SUBMISSION: CLINTON

a written submission by way of objection

RE: DA 2021 2362 1105 Barrenjoey Road Palm Beach
WRITTEN SUBMISSION: LETTER OF OBJECTION
SUBMISSION: CLINTON

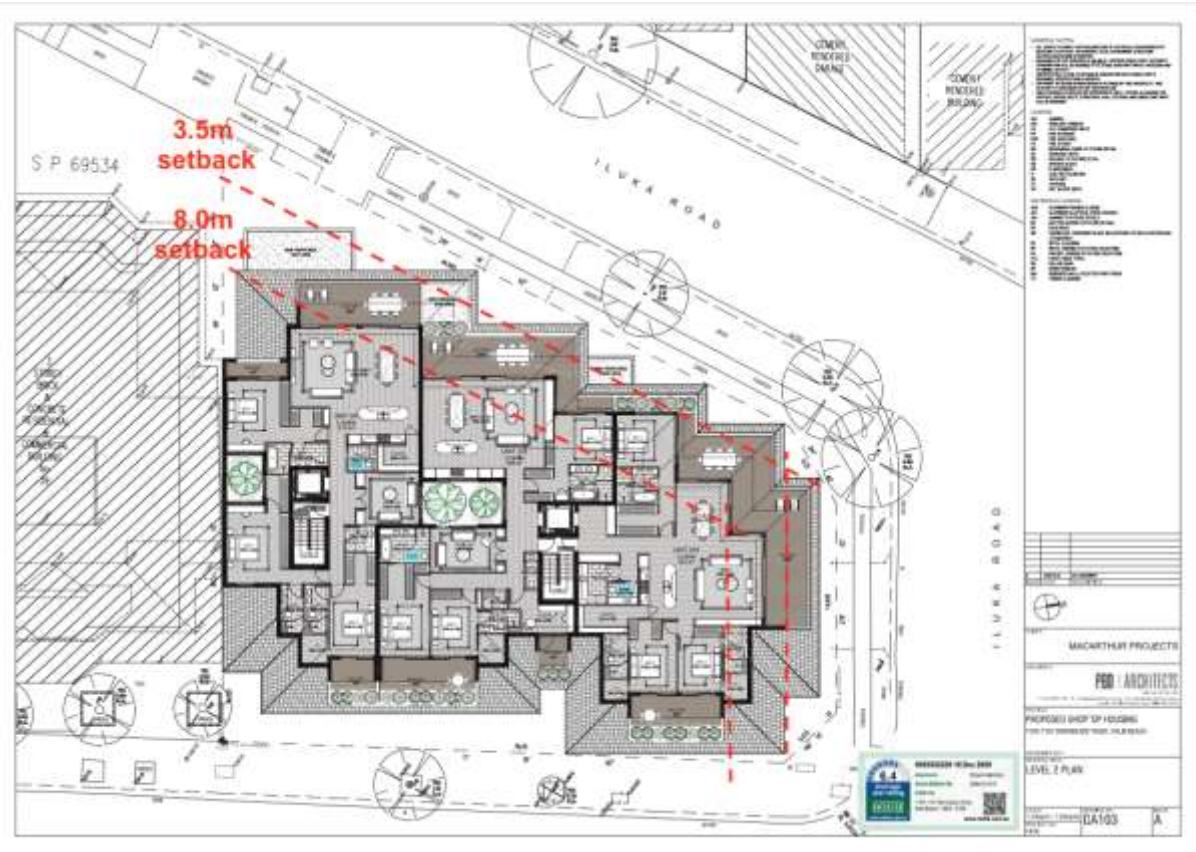
The proposed development does not provide an adequate setback area which would permit the planting of appropriate vegetation which could offer visual screening.

Excavation works and the proximity of existing trees to proposed building and structures will place ongoing issues with the arboricultural preservation of existing trees in the long term.
